May 28, 2020

ADDENDUM NO. 001 TO SPECIFICATION NO. 1398
Microwave Backbone Tower Sky Mesa, Hunter & Broderson Tank

**BRODERSON
TOWER ELEVATION**

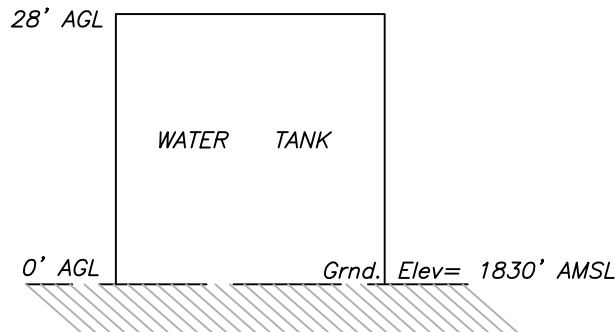
NOTE; The path to Daniel Pk & Perris requires fabrication of a mount on the water tank to achieve a workable path due to local trees.

E.M.W.D.		
HUNTER TANK TOWER ELEVATION		
Pathfinder Surveys Santa Fe, New Mexico (505) 471-6660	SCALE 1"=10' DRAWN BY MJS DATE JAN. 2017	REVISION 9966

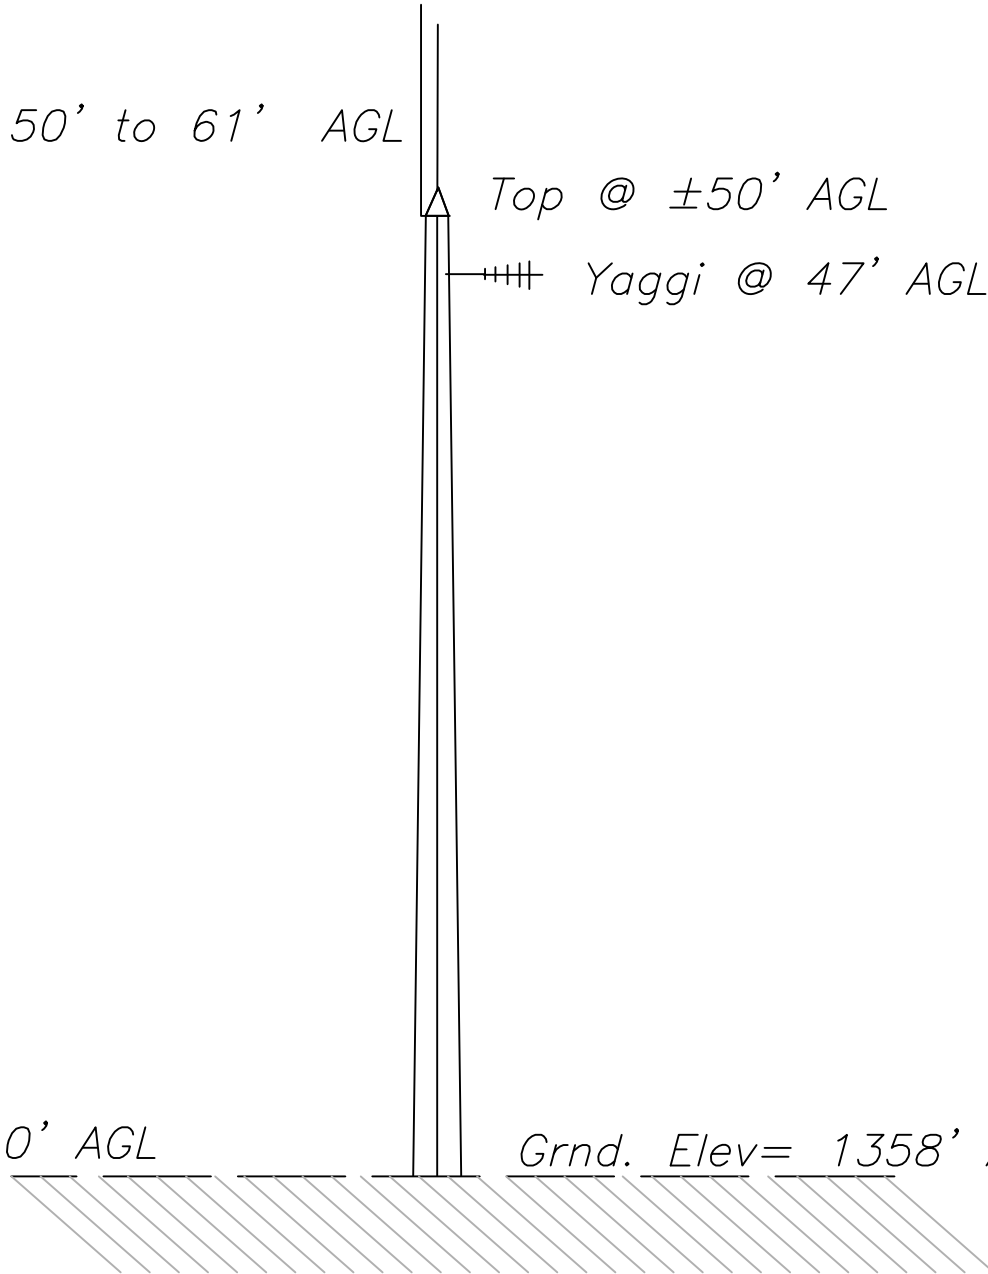
A4. The tower loading is shown in the attached tower elevation drawings.
